ADDENDUM NO. B

Community Day School Modernization
Merced, CA 95340
Client Bid No. 2025-5

DARDEN PROJECT NO. 2533
DSA File Nos. 24-35
DSA APPL. NO. 02-123716

The following additions, deletions, and revisions to the Sheets and Project Manual are hereby made and do become a part of these Contract Documents.

A/A100

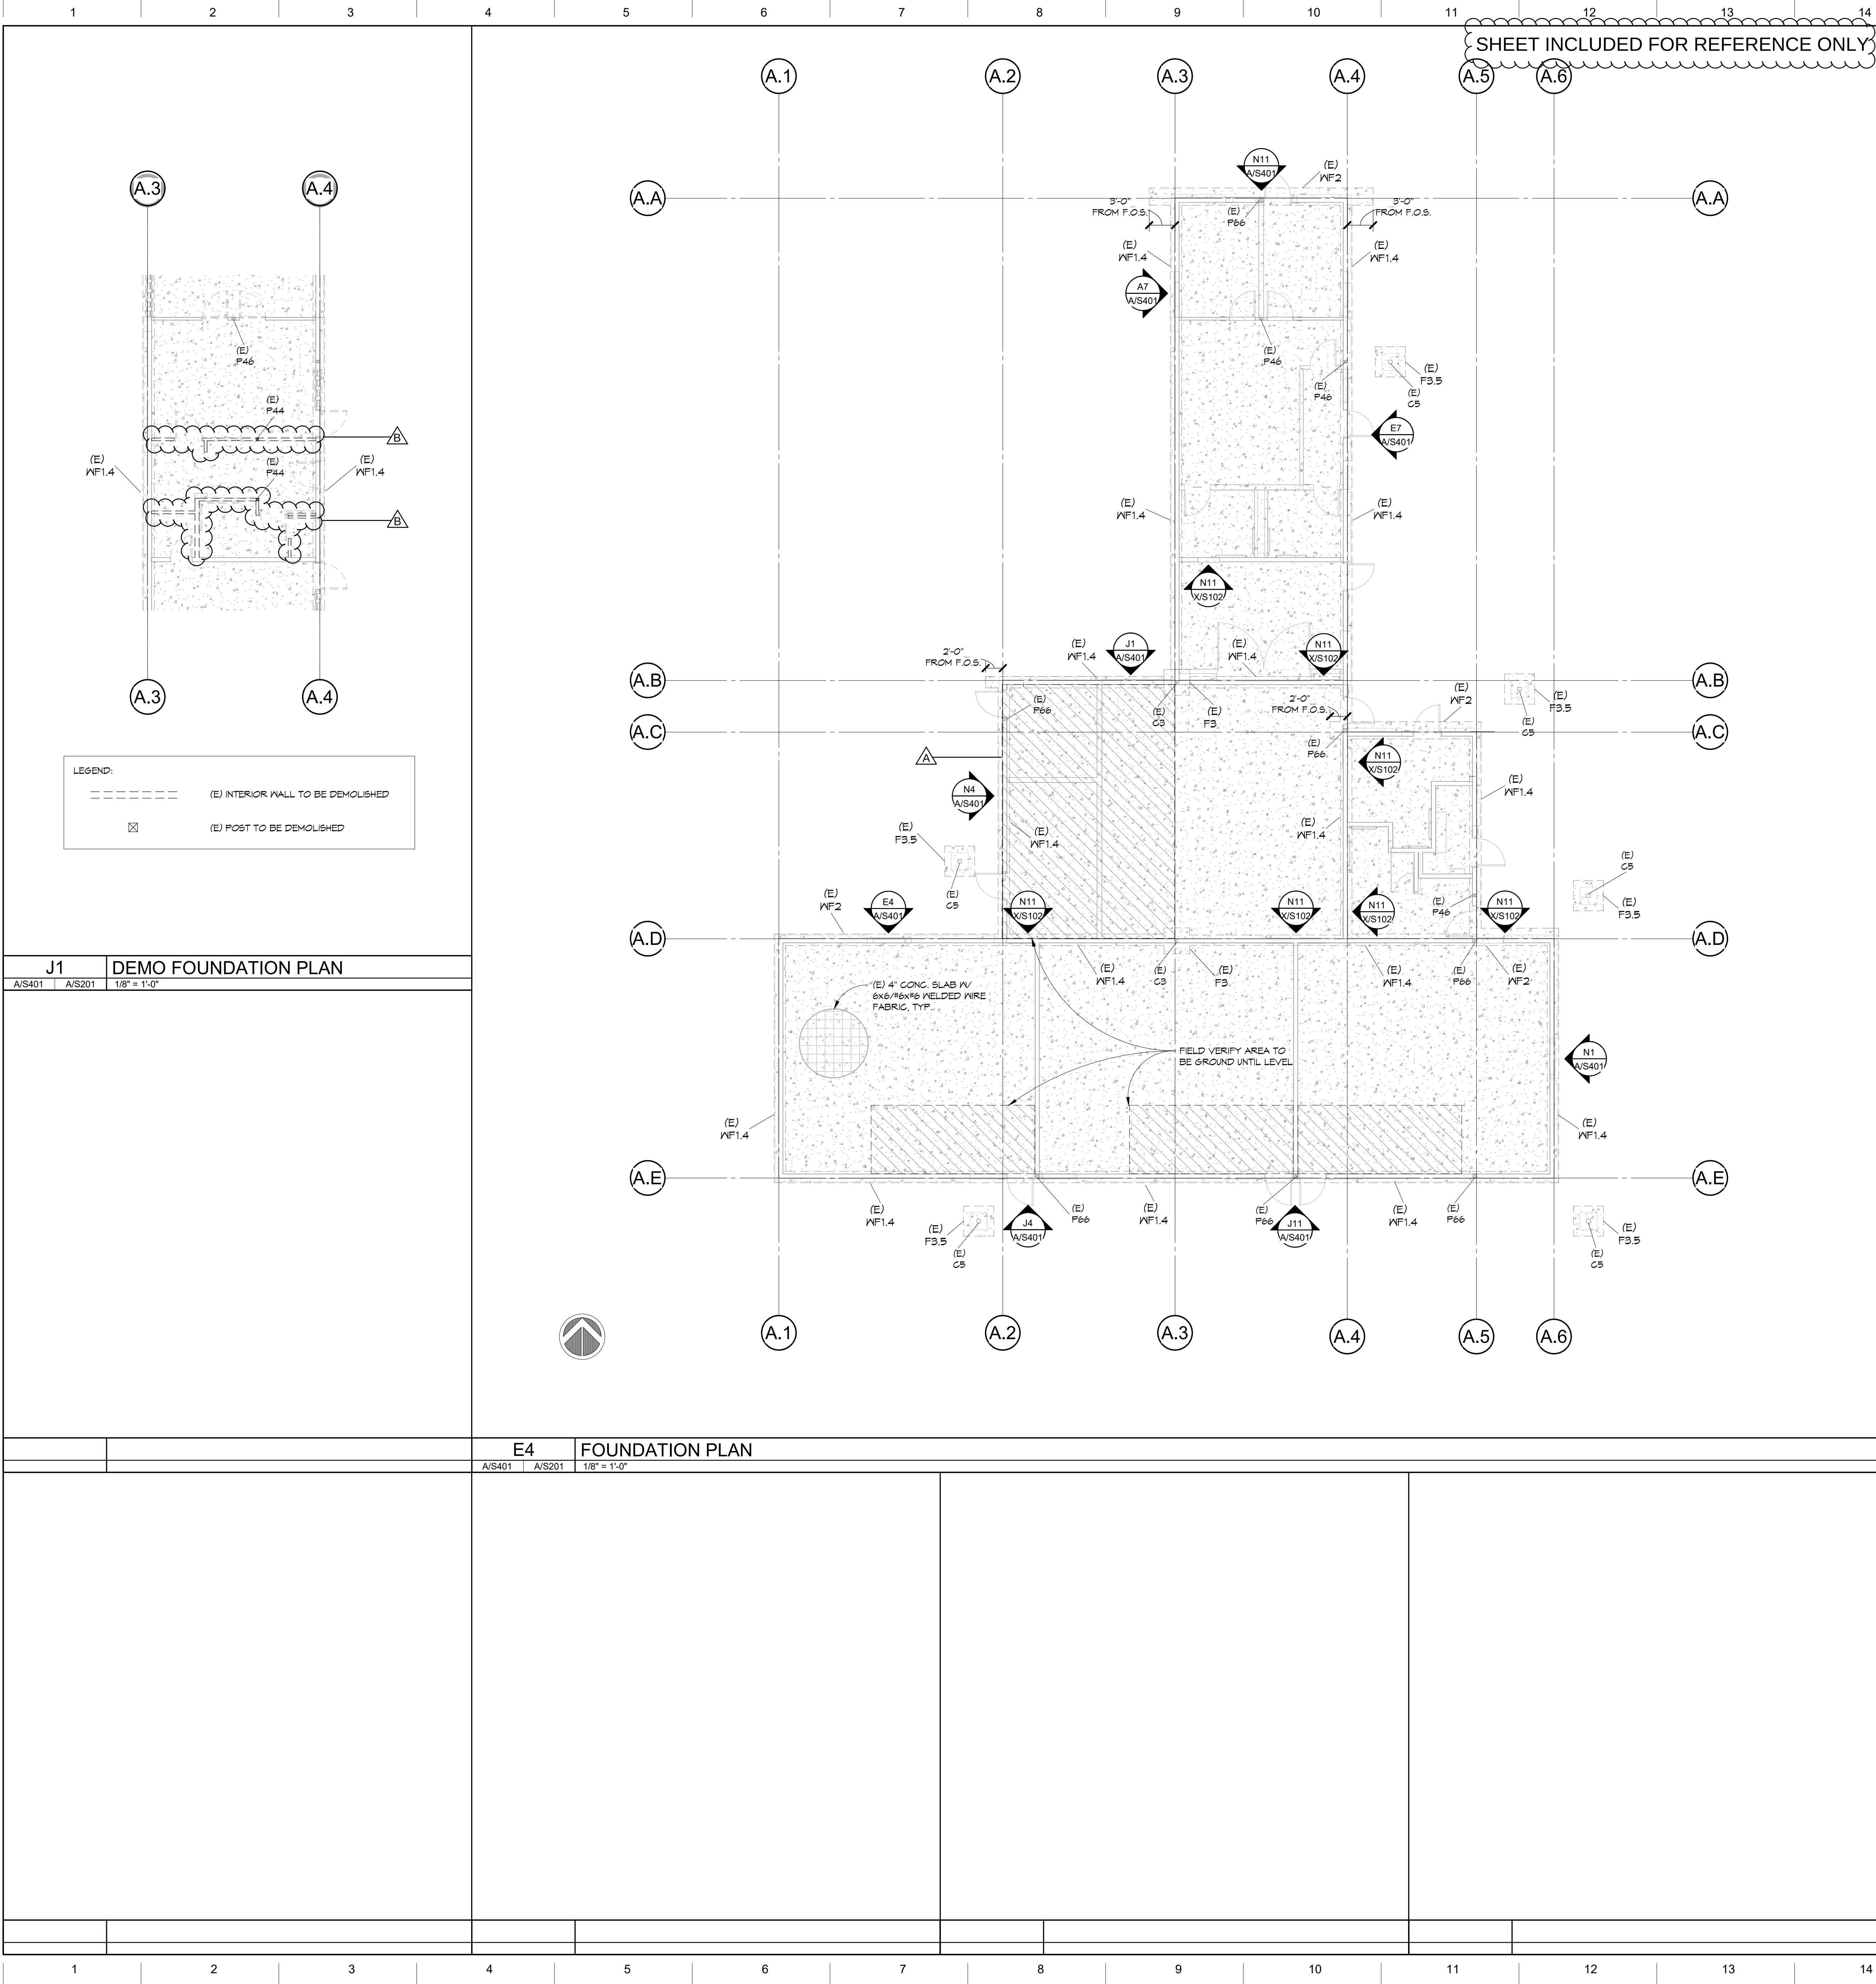
ADB-A01 Refer to Sheet A/A100, DEMOLITION FLOOR PLAN:

1. Refer to Sheet ADB-AX01. Demo Keynote 24 added to indicate the removal of Vinyl Tackboard. Changes are clouded.

- SELECTIVE DEMOLITION.
Remove and Retain for Reinstallation, Mirror
- SELECTIVE DEMOLITION.
Remove Vinyl Tackboard Finish and 1x Wood Trim, patch Gypsum Board where needed
